CERTIFICATE OF APPROPRIATENESS

**RE: Application Number 20-6984; 439 Henry; Cass-Henry Historic District
Project Scope: Rehabilitate Apartment Building**

RE: 439 Henry Street—Bretton Hall

Sheet
4A101

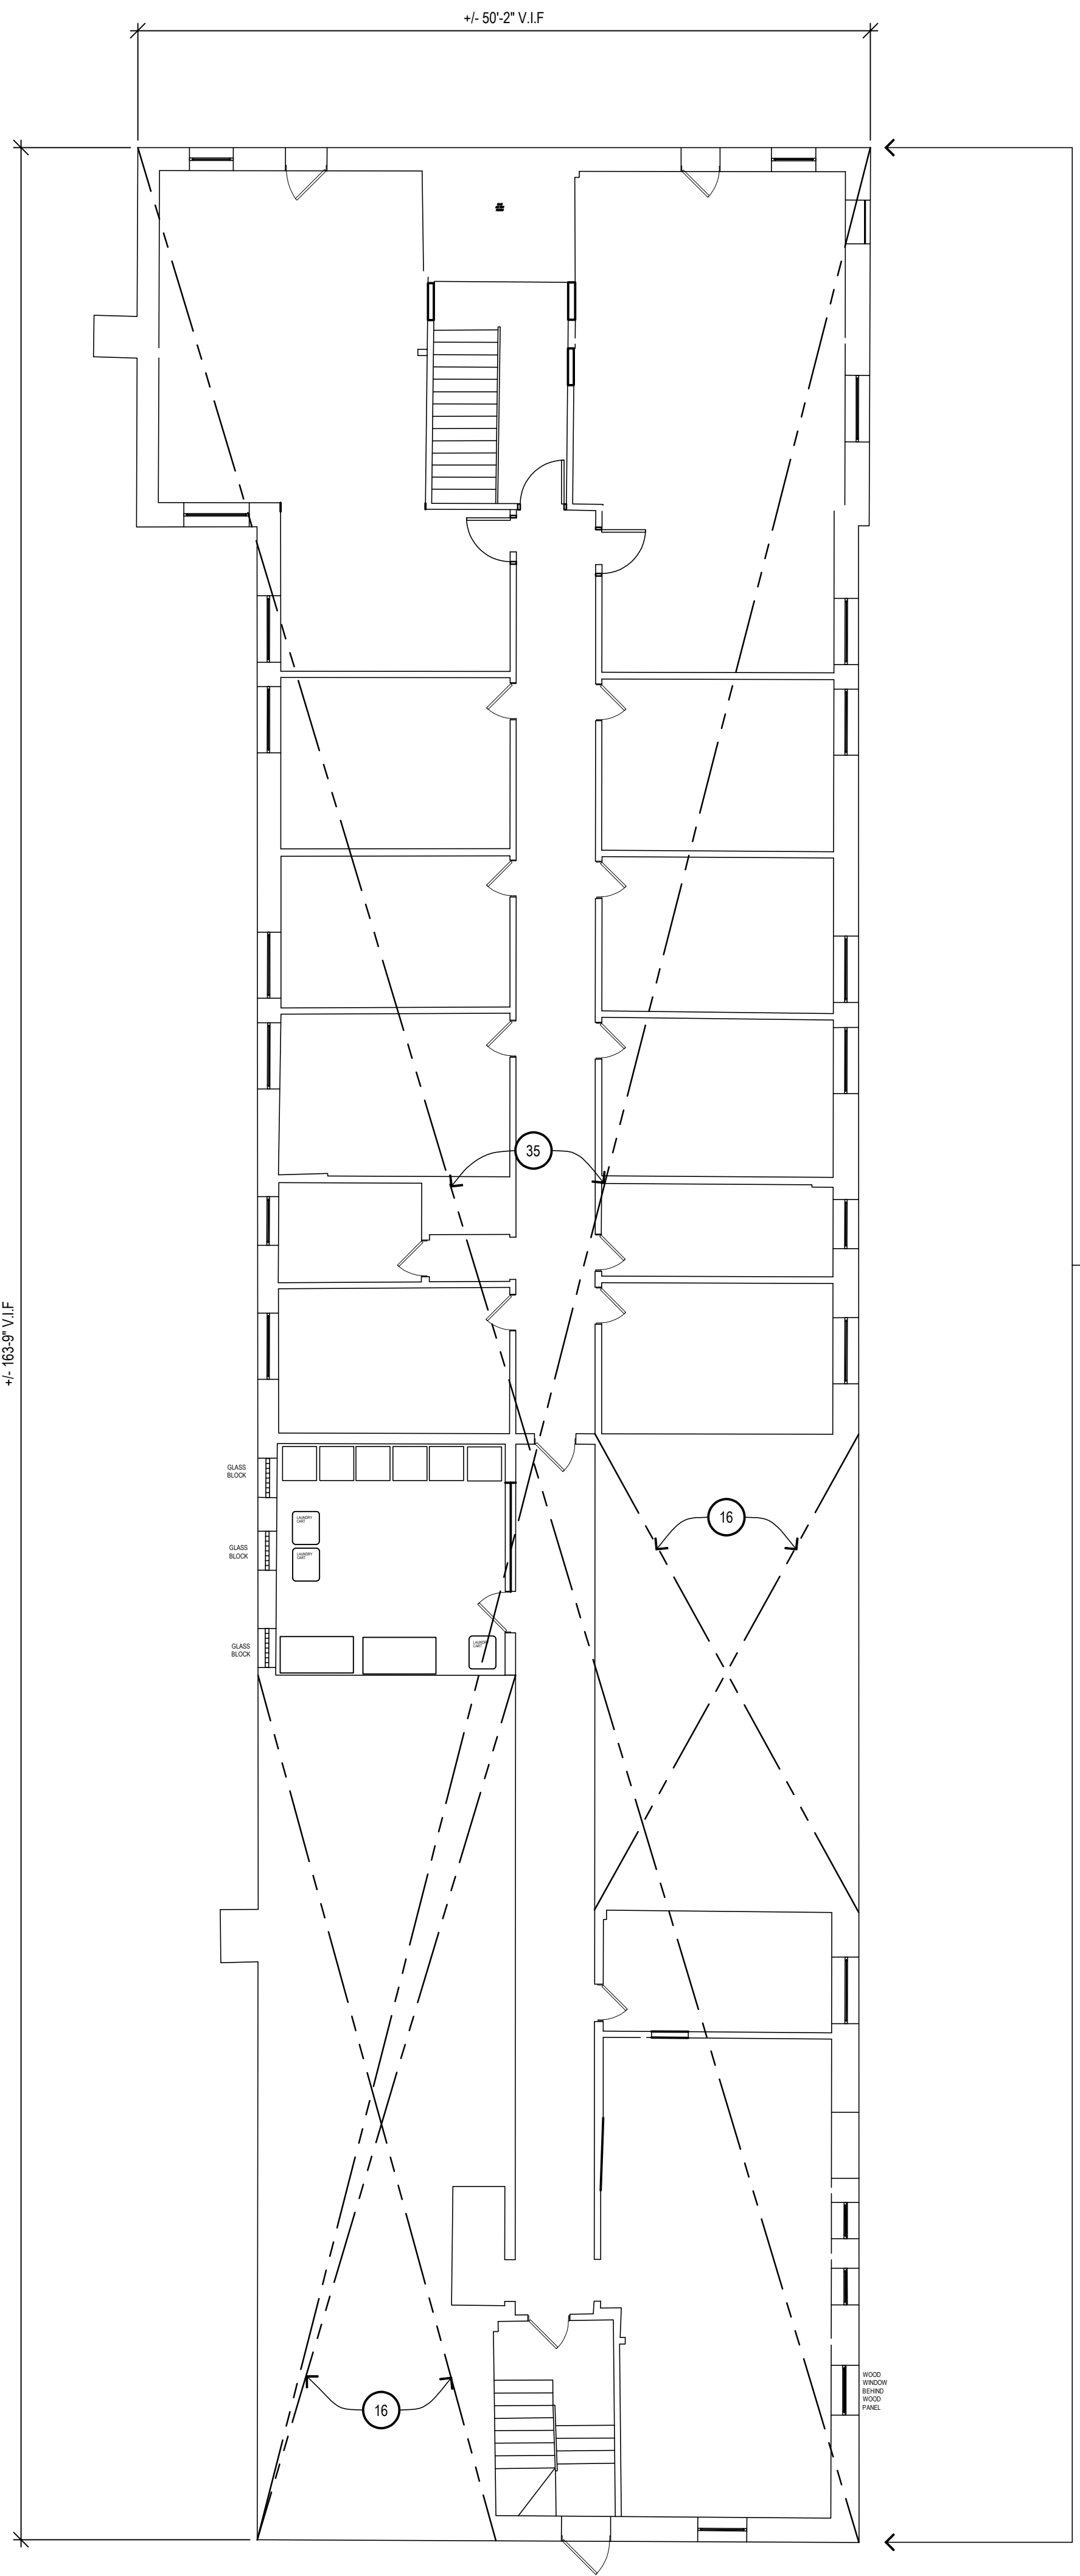
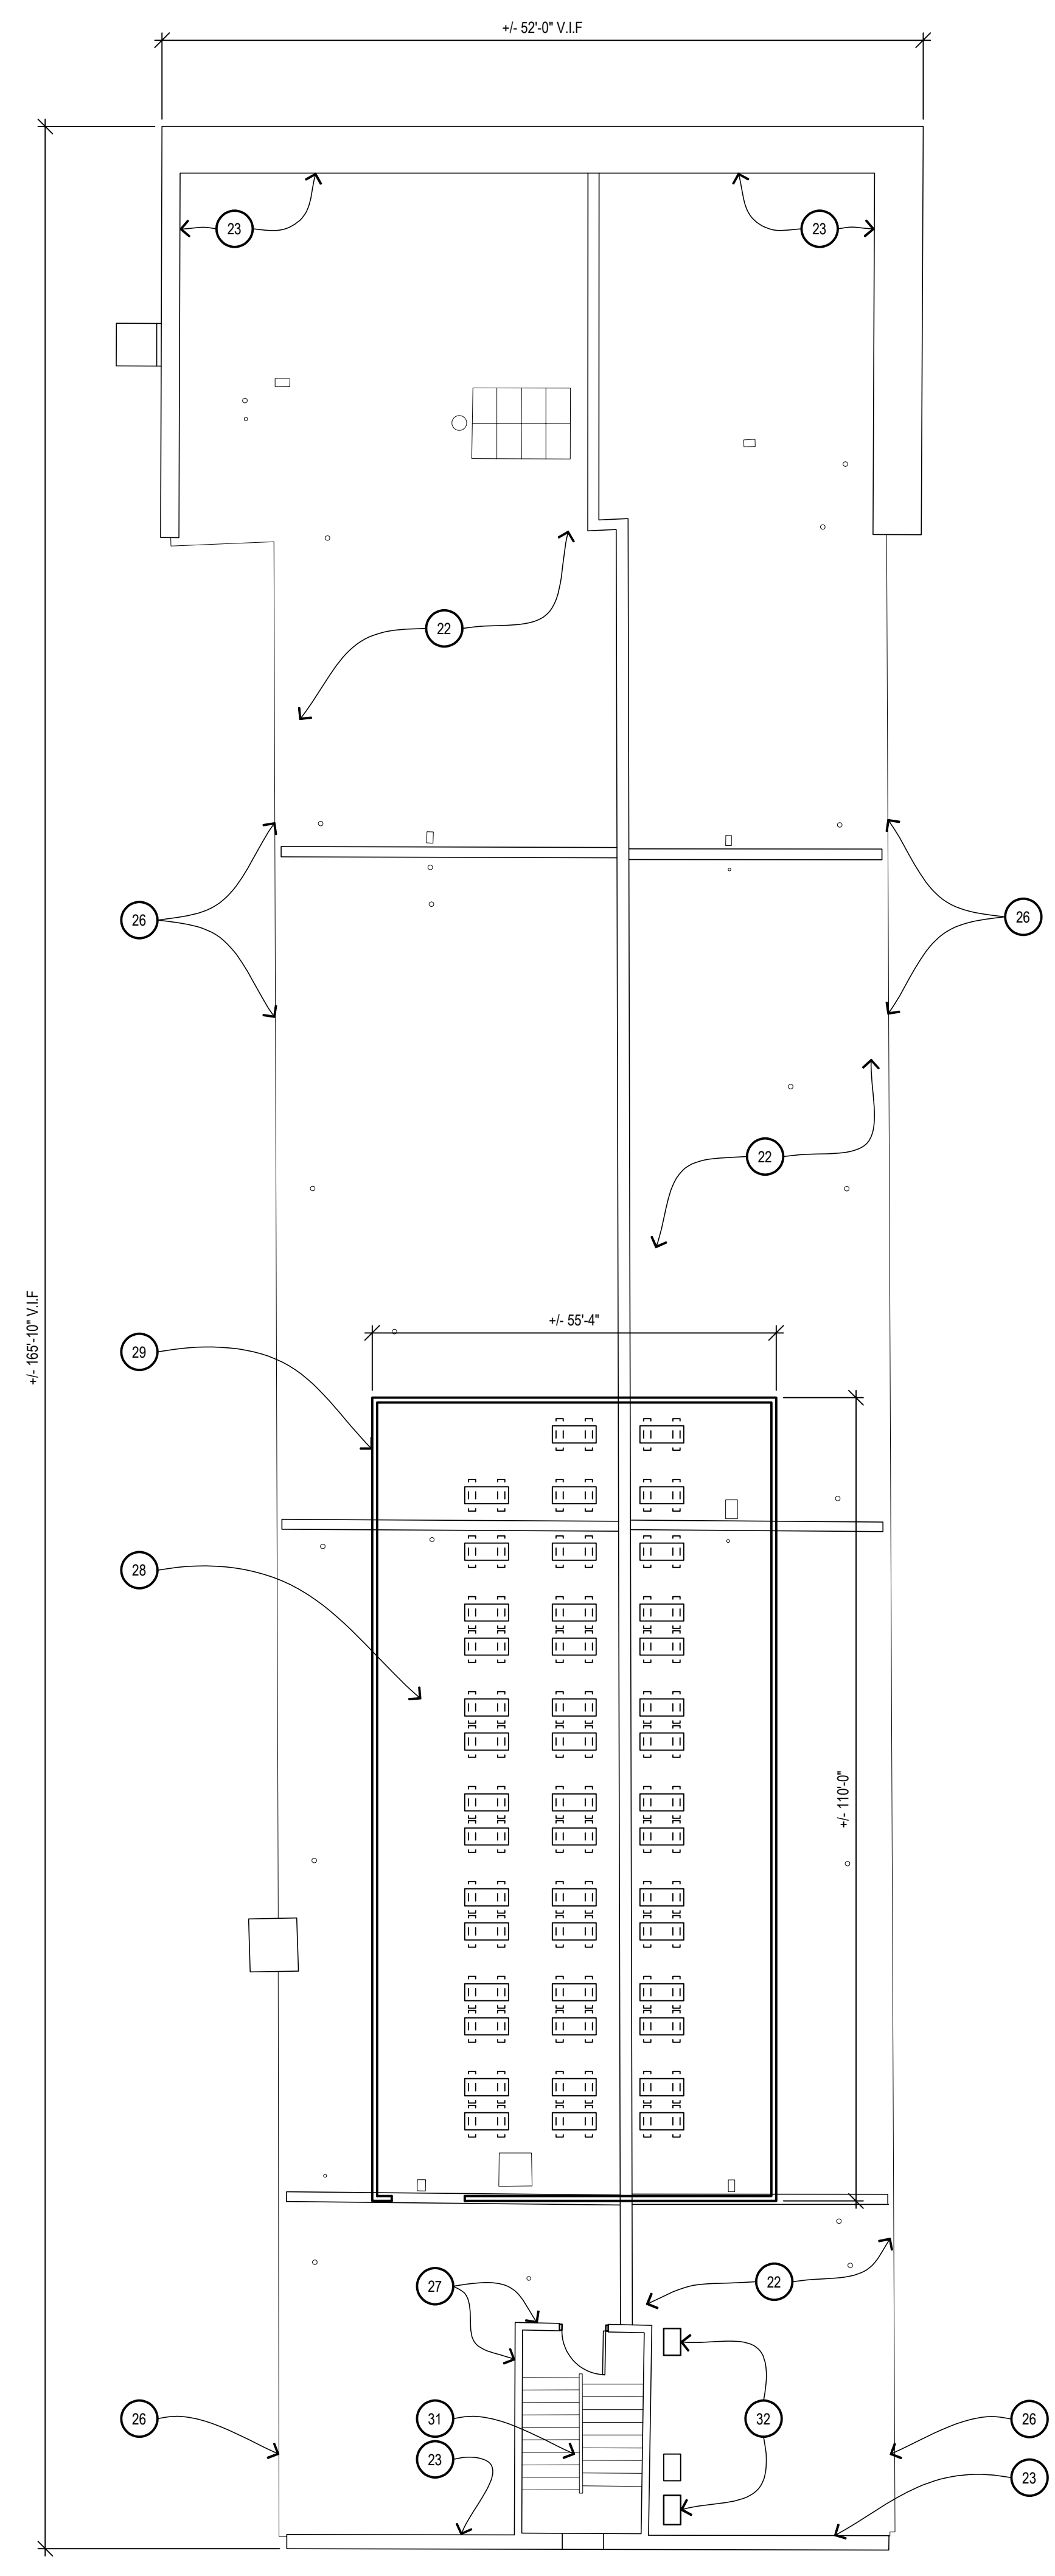
And, as per the submitted documents, specifically drawings 4A101, 4A102 (floor/roof plans) and 4A401, 4A401.1, 4A402, 4A402.1 (elevations)

- Staff review of the submitted construction drawings will include the identification of specific standards concerning repair and/or replacement of deteriorated character-defining features, and related standards concerning the qualifications of historic preservation contractors retained to perform the work.
- Staff review of the submitted construction drawings to specifically include review of specifications/cut sheets for lighting, windows, doors, ADA lifts, signage, paint removal, color choice, and other exterior elements not yet finalized, with staff authority to approve if per the Secretary of the Interior's Standards, the district's Elements of Design, and otherwise consistent with Commission intent and guidelines
- The historic name of the building, set in stone above the entryway, be preserved and remain visible.
- The historic double entry doors at the main entrance be preserved.
